CITY OF ALBUQUERQUE

RE: **Rohan Subdivision**
Lots 1P1 – 4P1
Requested for Pad Cert – Not Accepted
Engineers Stamp Date 6/29/15 (C19D042A)
Certification dated: 6-8-18

LOTS 1 THRU 4, ROHAN SUBDIVISION GRADING AND DRAINAGE PLAN

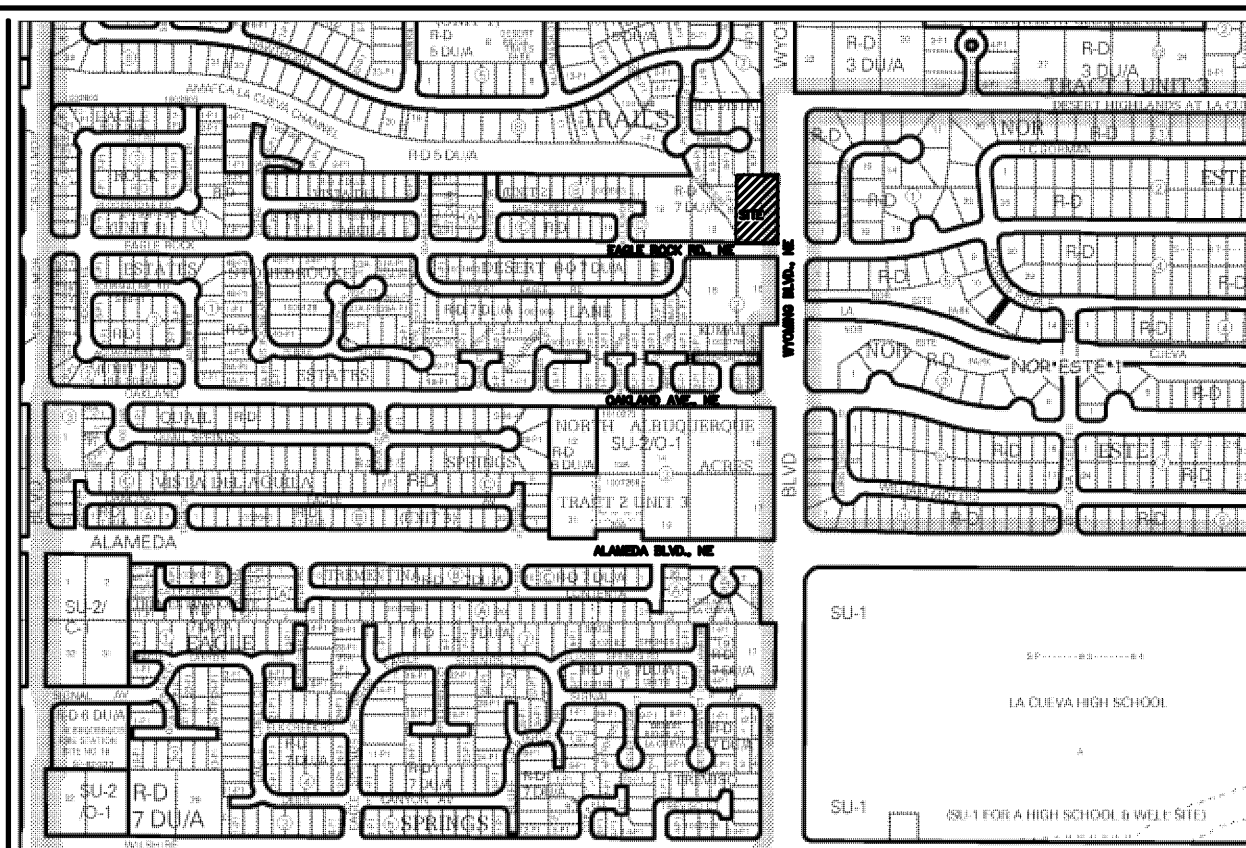
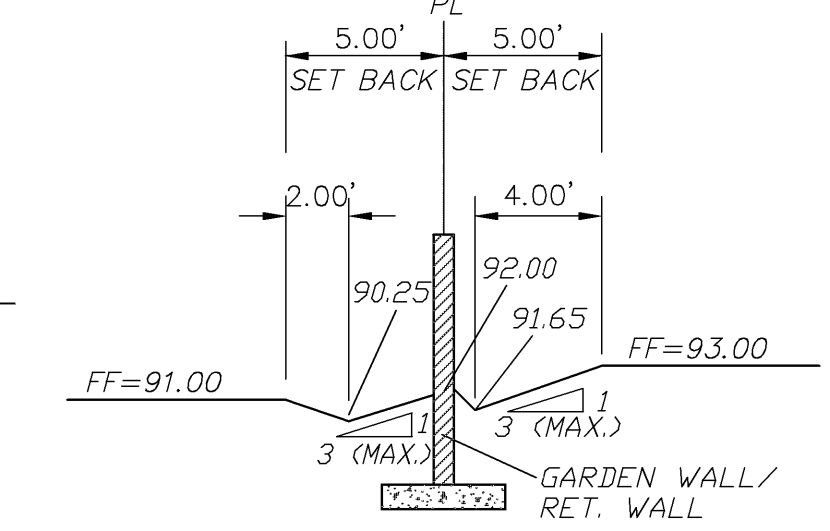
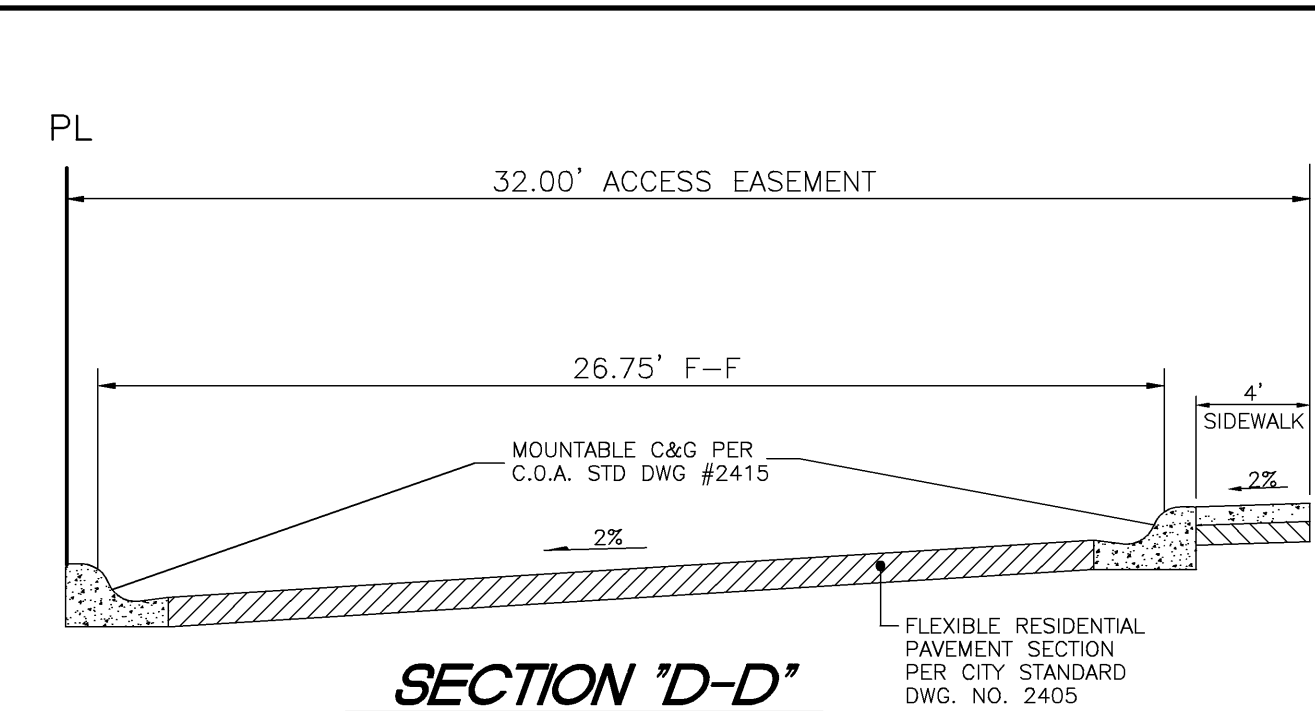
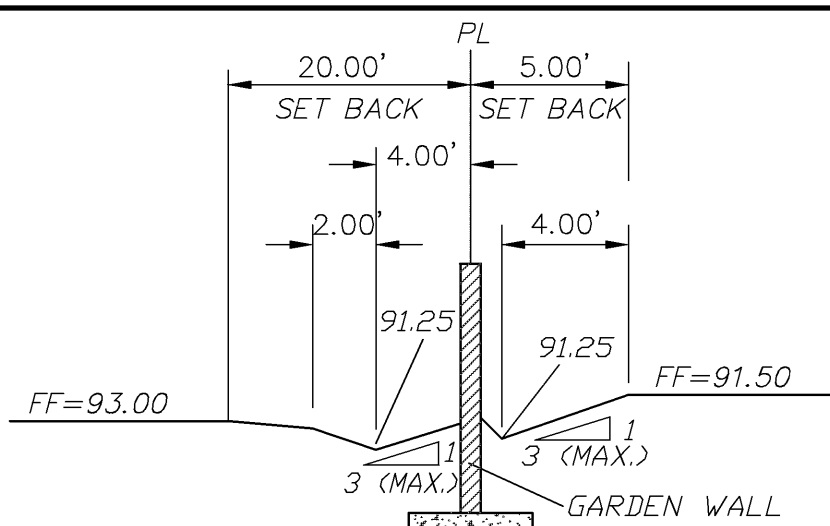
Based on the certification provided in your submittal received 6/19/2018, the above referenced site cannot be accepted for release of Pad Certification by Hydrology until the following comments are addressed:

- The private road must be paved.
- The retaining wall between the 2 lots must be completed.
- The 2' wide by 8" wall opening must be completed.

An inspection by our office will need to take place after these corrections are made.
